SAFETY OF HEPA FILTER UNITS IN HANFORD B-PLANT EXHAUST VENTILATION SYSTEM

This issue paper was prepared for the Defense Nuclear Facilities Safety Board by the following staff members:

April 15, 1996

Figure 2

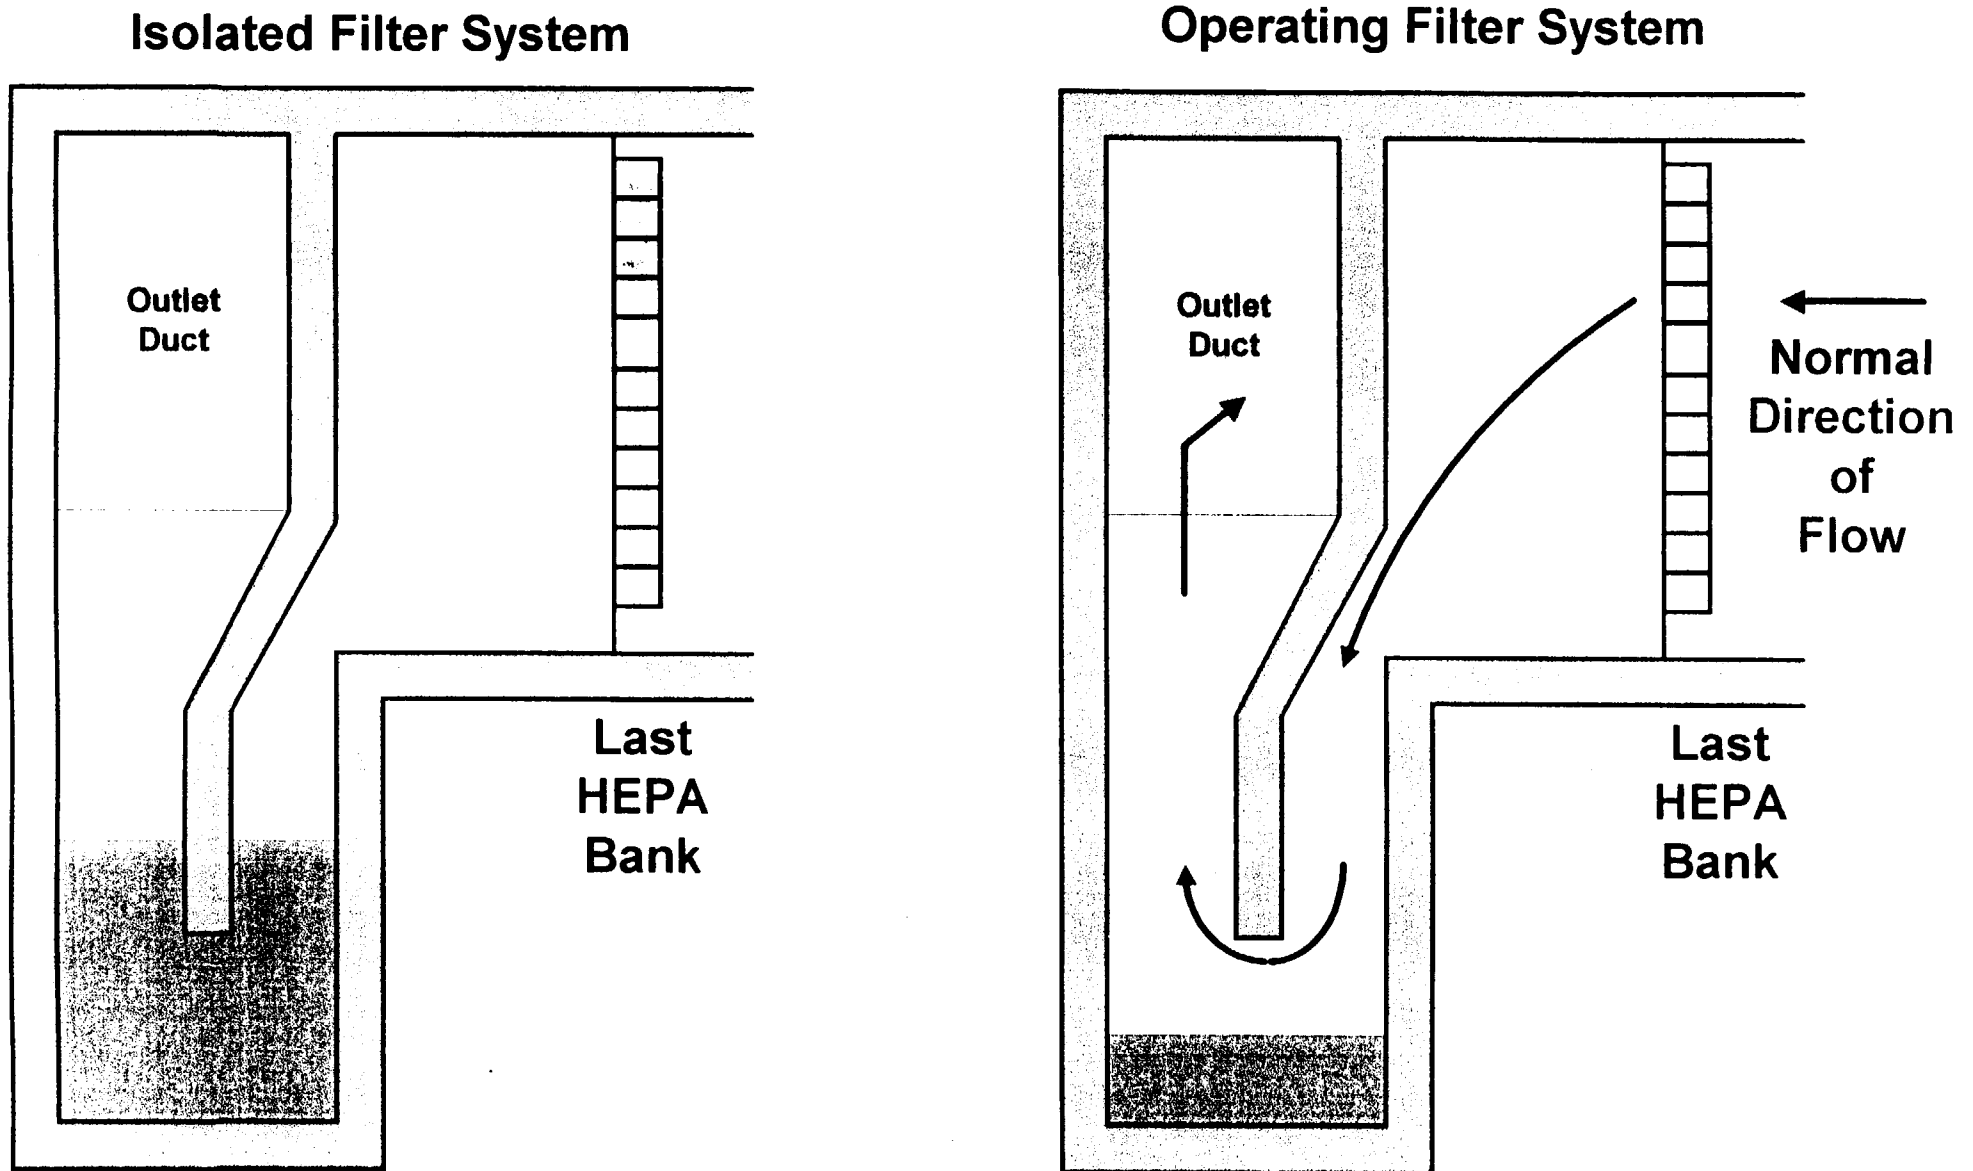
Although water seals may be appropriate for remotely operating inaccessible filter units, they do not provide a reliable long-term isolation function for retired or deactivated filter units. The water seals were not designed to meet single failure criteria and could be subject to inadvertent rapid draining (e.g., steam jetting) or gradual draining (e.g., evaporation, leaks). The water seals are also subject to overfilling that can flood the filter cells and wet the HEPA filters, which would further degrade the integrity of the filters. The flooding can also provide another mechanism for transport of radionuclides from the HEPA filters to the environment. As noted in Appendix A, retired filter units have been inadvertently flooded on two occasions.^{22,23,24}

In the past, WHC had considered various alternative schemes for isolating HEPA filters, including grouting and use of a nonvolatile liquid or foam material. All of these alternatives were rejected, and there are no near-term plans to replace the water seals. Leaving the outlet water seals of the retired filter units in their present configuration for several more years does not appear to be prudent. It appears that additional effort is warranted to identify an alternative that would provide enhanced reliability and not adversely impact future remediation of the filters. For example, the suitability of using a fine sand should be analyzed. The sand could be pneumatically and remotely substituted for the water, would be temporary, and would not be susceptible to inadvertent jetting.
